Safety Evaluation Report

Related to the SHINE Medical Technologies, LLC
Operating License Application for a Medical
Radioisotope Production Facility

Docket No. 50-608

February 2023

Figure 2-1: Comparison of SSE (yellow) with uniform hazard spectra for SDC-3 and SDC-4 facilities using site-specific subsurface information

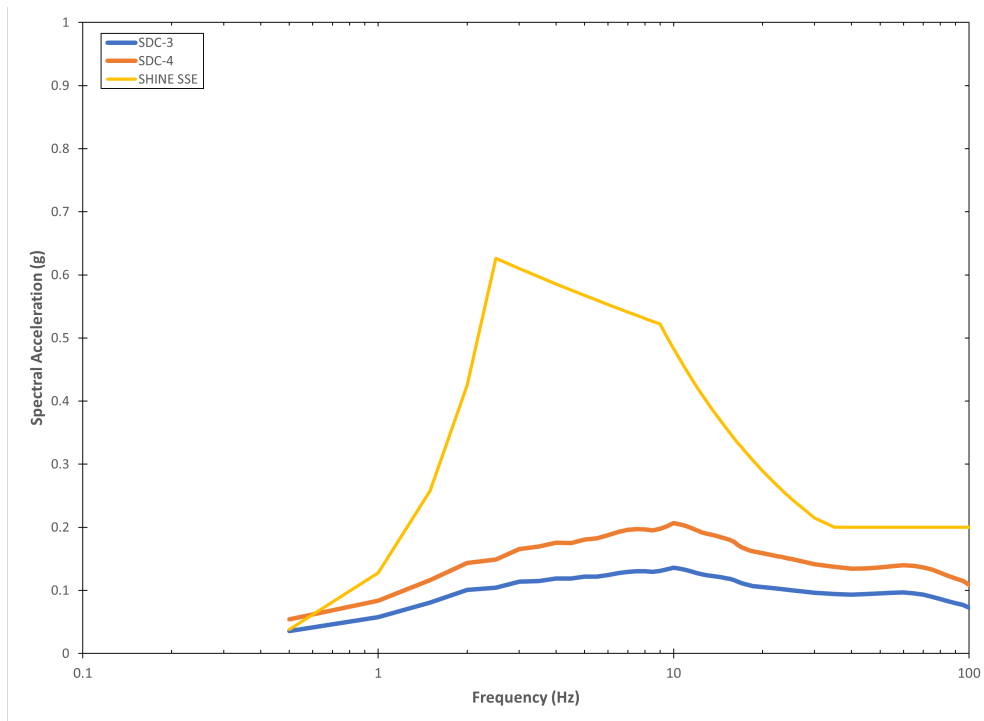
In addition to reviewing the application and the USGS results, the NRC staff performed a confirmatory PSHA that incorporates at-site information about the subsurface geology to develop uniform hazard spectra at the surface for Seismic Design Classification 3 and 4 (SDC-3 and SDC-4) facilities as defined in ANSI/ANS-2.26-2004, “Categorization of Nuclear Facility Structures, Systems, and Components for Seismic Design,” and computed following guidance in ASCE/SEI 43-05, “Seismic Design Criteria for Structures, Systems, and Components in Nuclear Facilities.” The staff used the seismic source model described in NUREG-2115, the ground motion model described in “EPRI (2004, 2006) Ground-Motion Model (GMM) Review Project,” 2013, and the site-specific dynamic properties described by the applicant in letter dated October 4, 2013 (ML13303A887), Enclosure 2 Attachment 26, “Preliminary Geotechnical Engineering Report (Janesville), Revision 3 (ML13309B618). The staff’s results, presented in figure 2.4.5-1, show that for an SDC-4 facility, the SSE envelopes the site-specific hazard at all frequencies greater than 0.6 hertz with significant margin. Greater margin is demonstrated for an SDC-3 facility.
